Detailed Site Plan
Departure from Design Standards
Alternative Compliance
Fariview

DSP-24015
DDS-24005
ACL-2025-0010

SUBJECT: Detailed Site Plan DSP-24015
Departure from Design Standards DDS-24005
Alternative Compliance ACL-2025-0010
Type 2 Tree Conservation Plan TCP2-2025-0075
Fairview

Figure 1: Detailed Site Plan

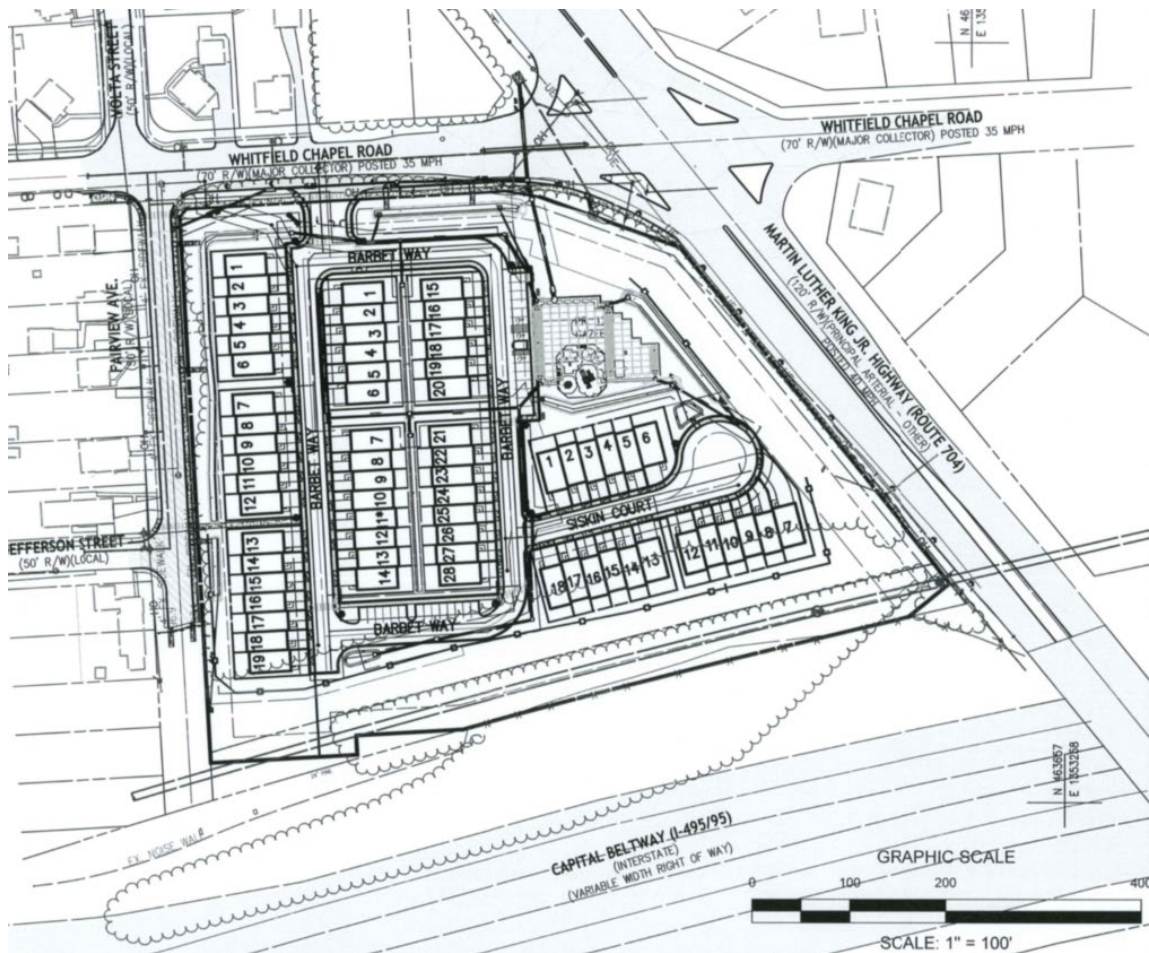
6. **Design Features:** This DSP includes 65 single-family attached (townhouse) dwelling units. The proposed development includes one vehicular access point on Whitfield Chapel Road. Within the subject property, private roads form the primary vehicular circulation of the site, providing access to 65 front loaded single-family attached (townhouse) units. The provision of crosswalks and 5-foot-wide sidewalks on both sides of the internal roads and along the property frontage of Whitfield Chapel Road and Fairview Avenue form the pedestrian circulation for the site.

Figure 5: Entrance Sign Elevation

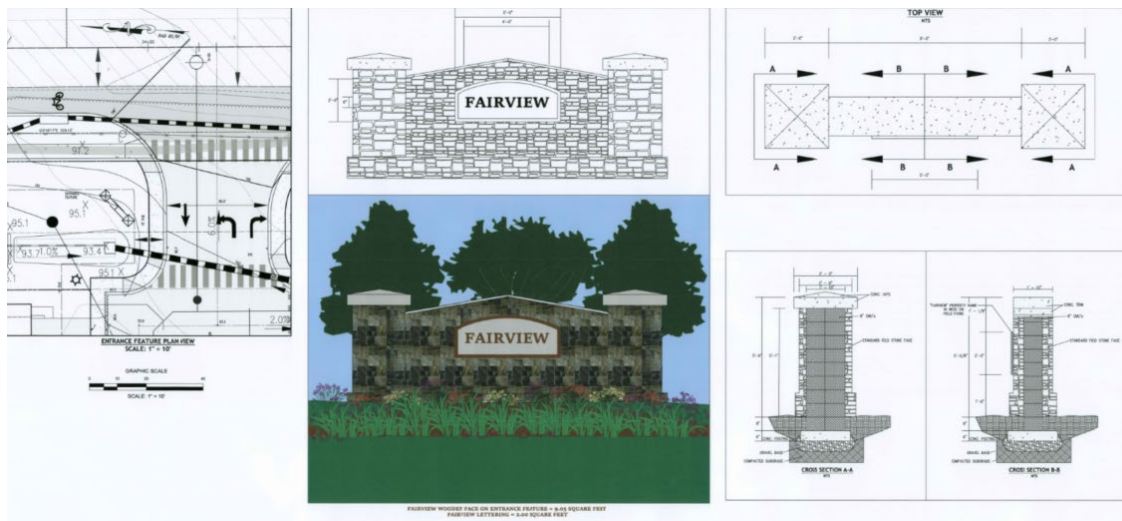
Section 27-614 of the prior Zoning Ordinance requires an analysis of signs based on Part 12 of the prior Zoning Ordinance. The DSP features one freestanding sign located north of the vehicular entrance to the site on Whitfield Chapel Road and is 10 feet behind the street line. The sign includes two decorative columns with a central gabled section. Materials consist of standard field stone, concrete trim and cap, and concrete footing. No illumination is proposed. Landscaping at the base of the sign is included. The freestanding sign is 5 feet and 6 inches in height. The plaque, which is the letter area, is measured 5 feet in length and 2 feet in height, for a total of approximately 10 square feet. Pursuant to Section 27-614(c)(3)(B), the maximum allowed sign area in all commercial zones are as follows: 1-square-foot for each 4 lineal feet of street frontage, to a maximum of 200 square feet for each sign, if the business is not located in an integrated shopping center, other commercial center with 3 or more businesses served by common and immediate off-street parking and loading facilities, industrial center, or office building complex. The street frontage shall be measured on the property occupied by the use associated with the sign. The subject property has street frontage on four sides. Staff estimated the street frontage is approximately 2,200 feet. As such, the maximum sign area allowed is 200 square feet. The proposed signage meets the sign requirements pursuant to Section 27-614.
